**Project #19-030
Logan Riverwalk Commercial Building
Locate at 80 East 400 South**

Project Name: Logan Riverwalk Commercial Building
Proponent / Owner: Bracken Atkinson
Project Address: 80 East 400 South
Request: Design Review
Current Zoning: Commercial (COM) & Mixed Use (MU)
Type of Action: Quasi-Judicial
Hearing Date: August 22, 2019
Submitted By: Russ Holley, Senior Planner

Staff recommends that the Planning Commission **conditionally approve** a Design Review Permit for Project #19-030, Logan Riverwalk Commercial Building for a 35,000 SF office building located at approximately 80 East 400 South, TIN #02-054-0054; -0008; -0009; -0043.

C-101

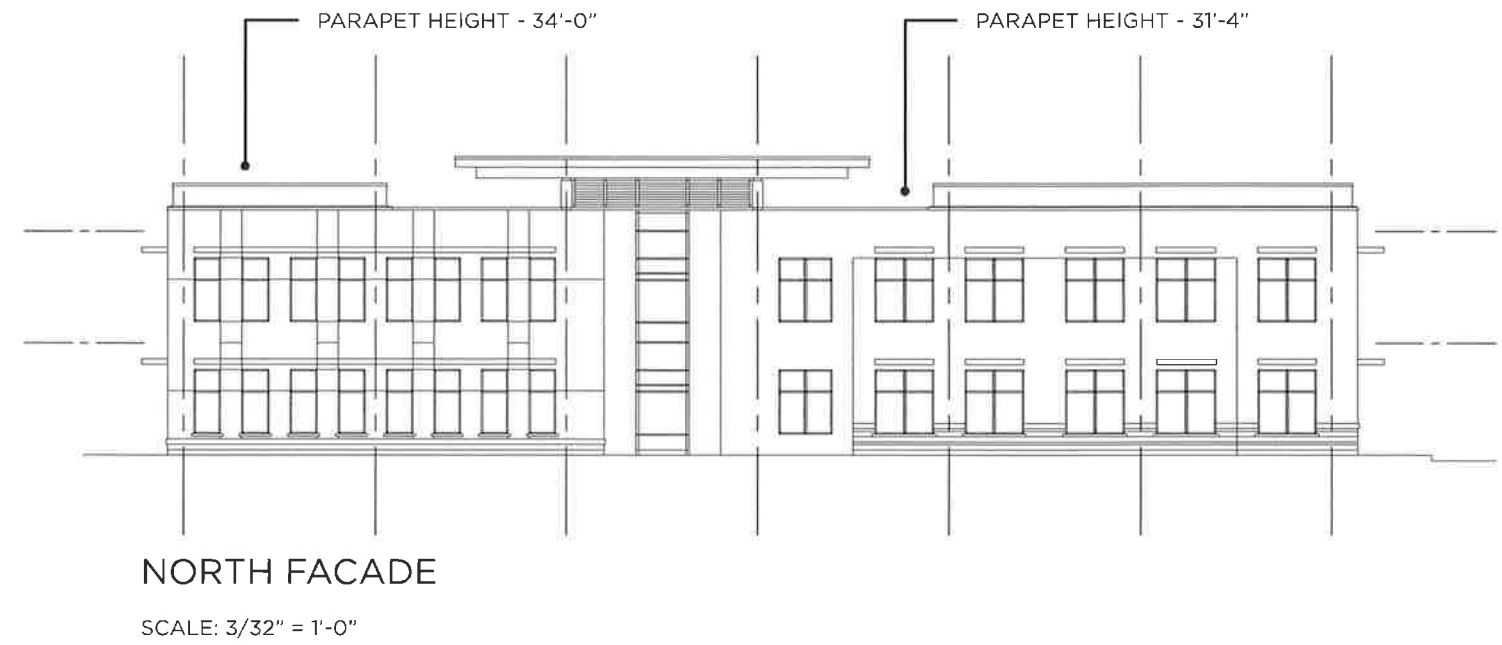
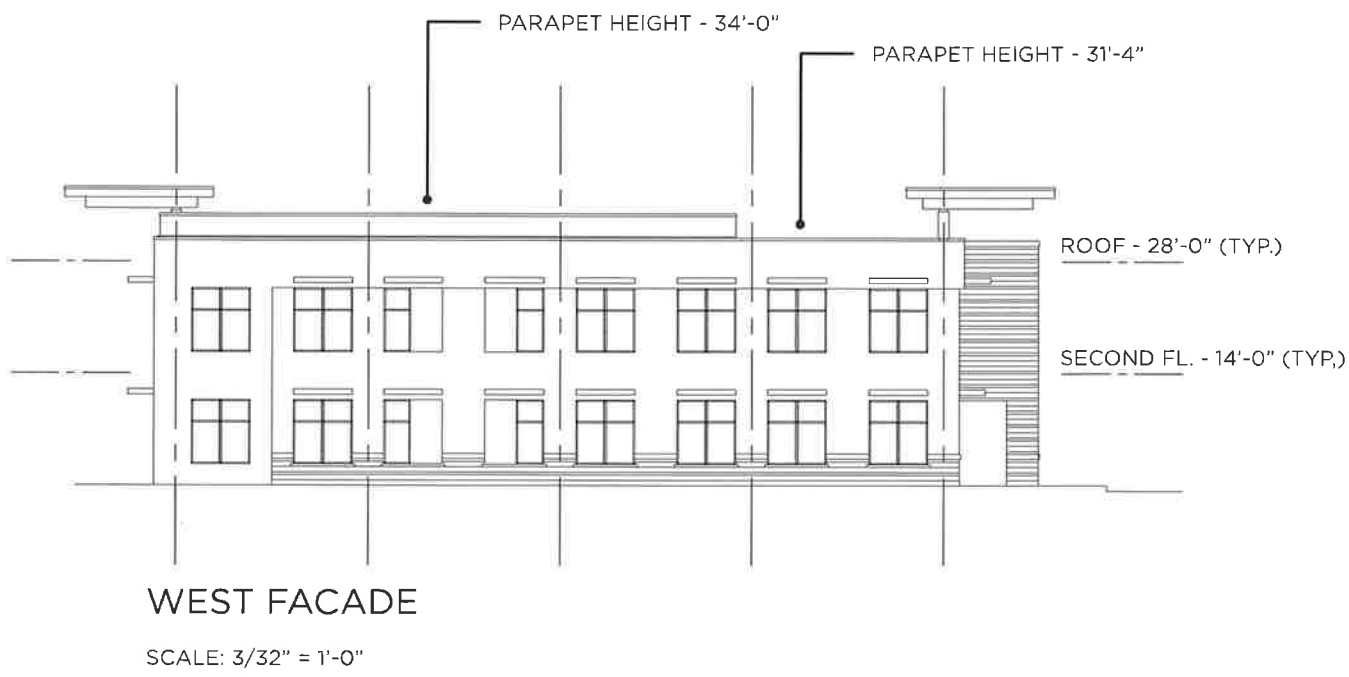
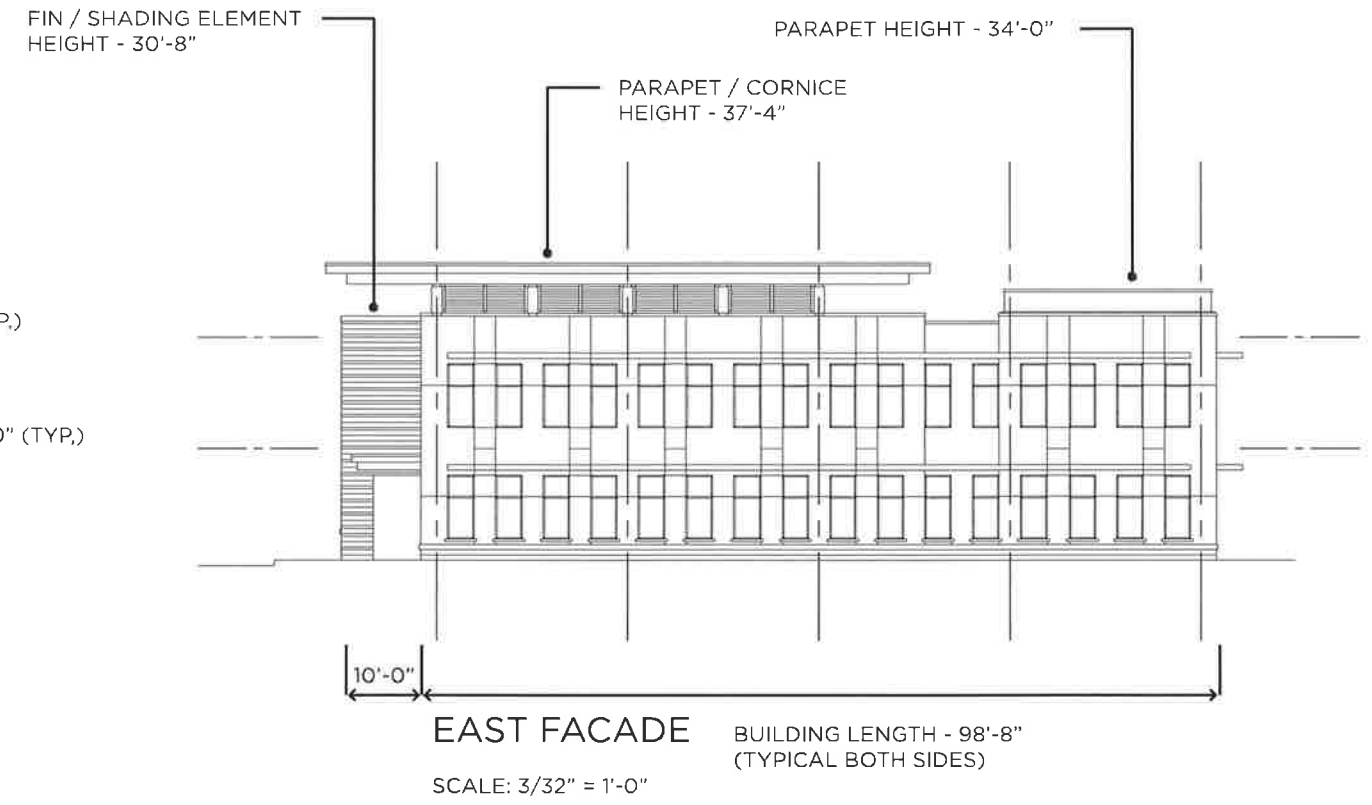
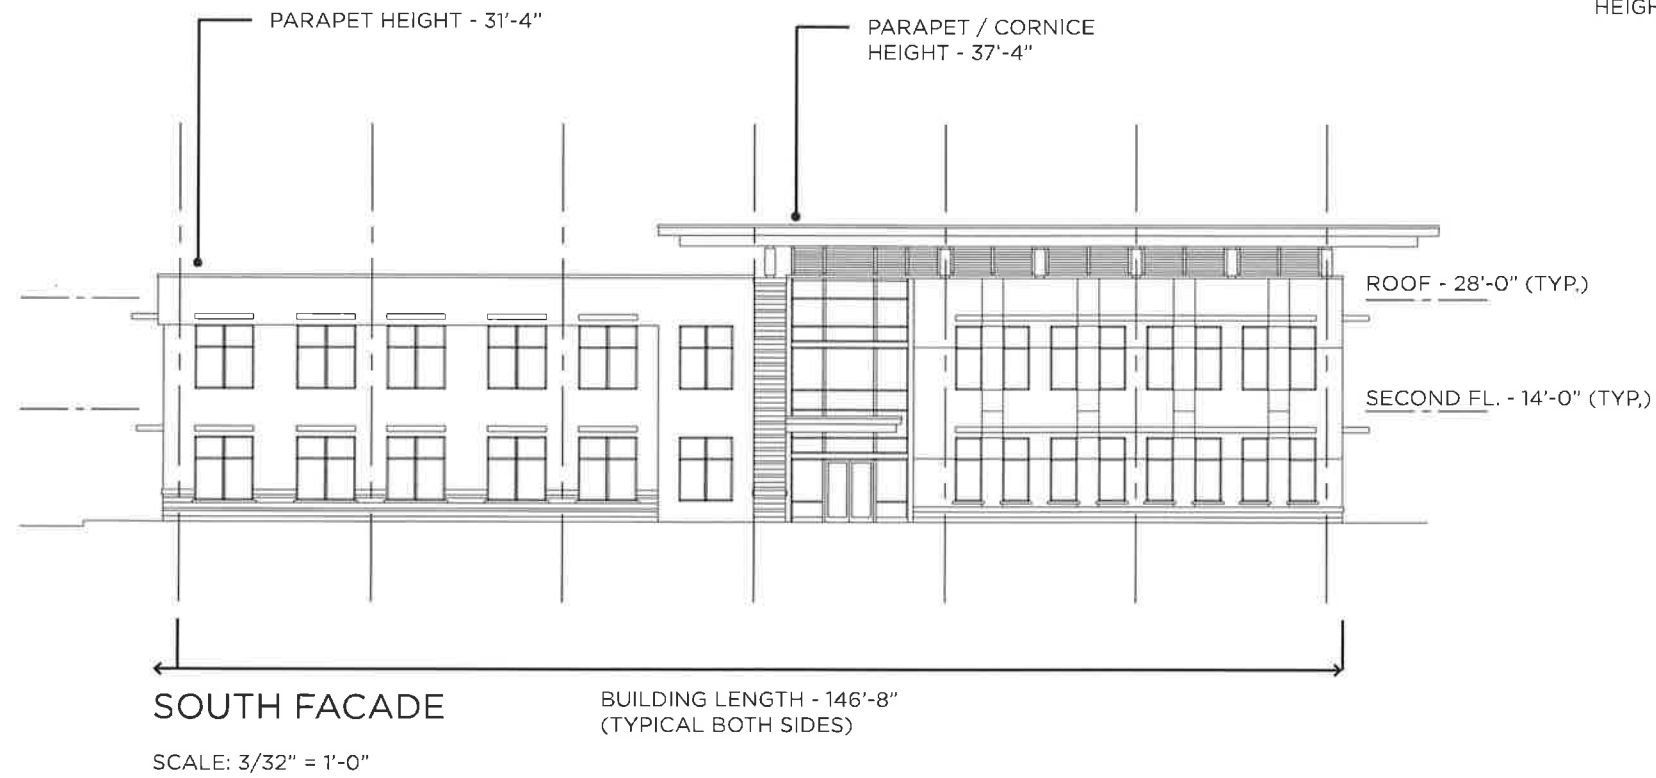
As conditioned with the enhanced front and corner setbacks of 25’ and 20’ in areas adjacent to NR zoning, the project complies with the requirements in the LDC.

The proposed building meets minimum transparency requirements in the LDC. The rear façade adjacent to the parking lot has an entry feature with an additional significant amount of glass creating a building design that is not considered 4-sided architecture. As conditioned with architectural features and transparency levels similar on all 4-sides, the project complies with the requirements in the LDC.

The LDC allows for buildings to have primary entrances not oriented towards the street if the building façade facing the street has similar architectural features and as the primary entrance/façade. The commercial building has an entry on the front façade adjacent to 400 South street but does not contain similar architectural features found on the rear façade facing the parking lot. As conditioned with similar entryway architectural features in the front and back, the project complies with the requirements in the LDC.

For an office, the LDC 17.31 requires vehicular parking at one (1) parking stall per every 300 SF of office space. At approximately 35,000 SF of office space, 116 parking stalls would be required. As proposed, 120 parking stalls are provided meeting LDC requirements. The LDC requires bike racks in commercial areas. As conditioned with minimum parking stalls and a bike rack, the project complies with the requirements in the LDC.

3. The front yard building setback (north) shall be 25' and the corner yard building setback (east) shall be 20' to match the NR zones across the streets.

4. The building shall have 4-sided architecture with rear façade architectural features matching front facades. All entryways shall have minimum weather protections and features that emphasis inviting entrances.

5. All frontage and exposed ground floor sides shall meet 30% transparency requirement.
6. A minimum of 116 parking stalls shall be provided for the office at a ratio of one (1) parking stall per every 300 SF of office space. A bike rack shall be installed on-site for bike parking.

7. Parking for the commercial buildings will be located in the side or rear yard.
8. A minimum parking setback of 10' along 400 S is required. A dense landscaping buffer will be constructed between the parking and the sidewalk along 400 S and 100 E. The buffer shall conform with Type "C" Separation LDC 17.32.070.B.
